M-2014-045

Response to DRMS October 20, 2014 Comments1 message

**Responses to Division of Mining Reclamation and Safety (DRMS) Adequacy Review of Letter Dated
October 20, 2014**

By C. A. Braun PE-CPG – December 9 , 2014

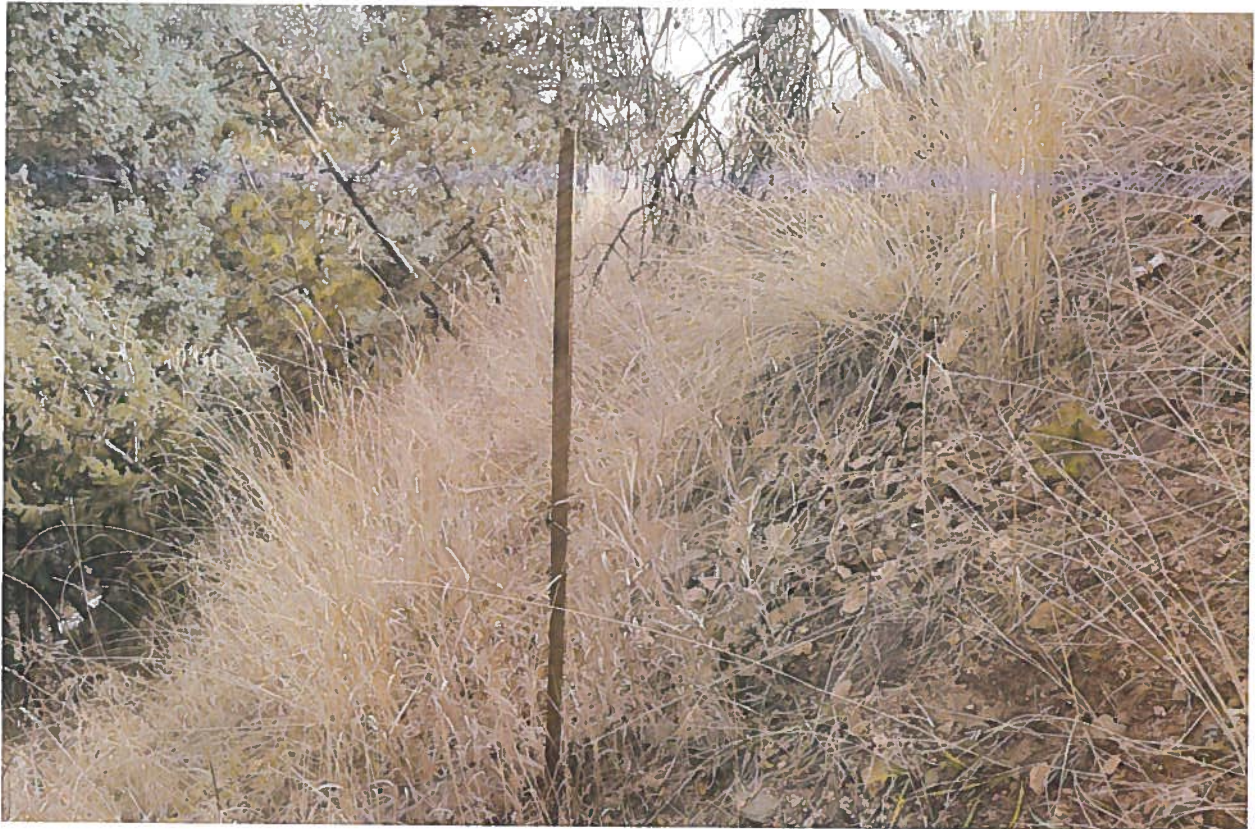
Comment 8 - Temporary Structures – DRMS acknowledges slopes of up to 1 to 3 from a topo map paragraph (b) and demands photographic proof of establishment of grass on steep slopes

Photo 1 is a view of an access road on westerly-facing slope – The lower embankment of the road ranges from 6 to 10 feet in height. The area shown is completely vegetated and stable.

Photo 2 is a view of a reclaimed mine road on a hillside slope of just under 30 degrees. A trace of upper road bank can be seen in the snow at the center right in the photo. Care was taken to cover rocks with all available soil during reclamation, along with diligence in covering the seed. Note the smooth surface with no rilling.

Photo 3 shows an area located less than 75 yards from the Photo 2. Note the lack of the thick grass visible in the previous photo. This area is undisturbed and natural. Disturbance has improved the soil.

Photo 4 is of a mine road crossing an area having an average slope of greater than 30 degrees. The lower bank of the road cut is at the higher angle of 33 degrees, just below the angle of repose. Vegetation has been successfully established on that road bank and the interface between the disturbed soils and the non-disturbed soils is difficult to recognize in the photo.

Photo 5 is of a north facing slope on a newly deposited waste rock surface. The stake was placed in the photo to provide a reference point to show that the slope is clearly at angle of repose. The grass visible in the photo has been successfully established and a small sapling tree is also visible at center right. Note that even though the grass on the right is thinner than the lush grass on the left, there is still a great deal of growth and root mass. The lower volume in this area is due to shading from trees. Reclamation at this location was initiated in 2012 and the total bank height is approximately 25 feet, a similar magnitude as the waste rock pile in contention. This site survived a 3-inch storm event which occurred in 2012 with no damage to the grassed slope.
